Addendum No. 3
Path Construction Project
South Dogwood Trail
Southern Shores, Dare County, North Carolina
August 30, 2019

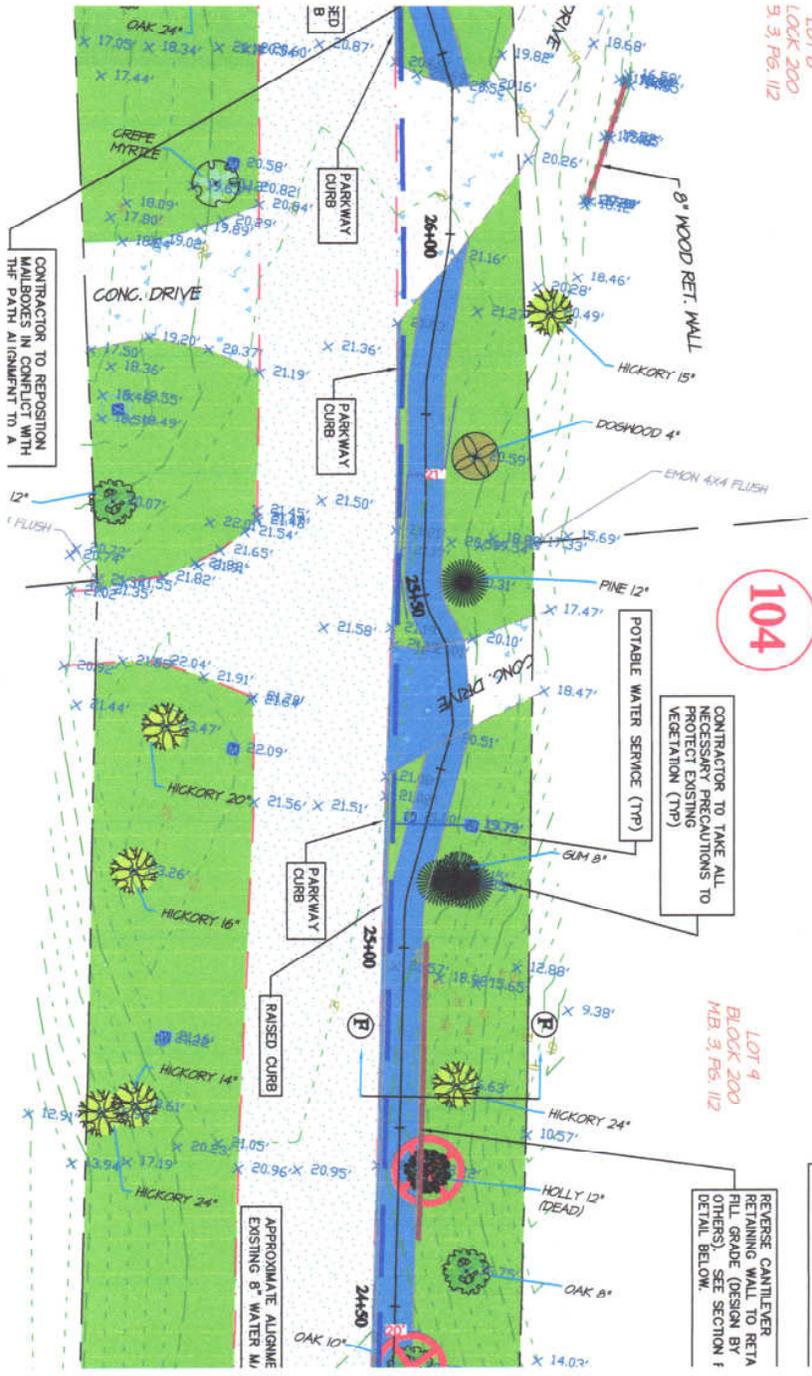
1. Due to the condition of the existing driveway apron at 104 South Dogwood Trail the plans have been revised to include a concrete driveway apron replacement at this location. Please see the sketch for the proposed apron limits.
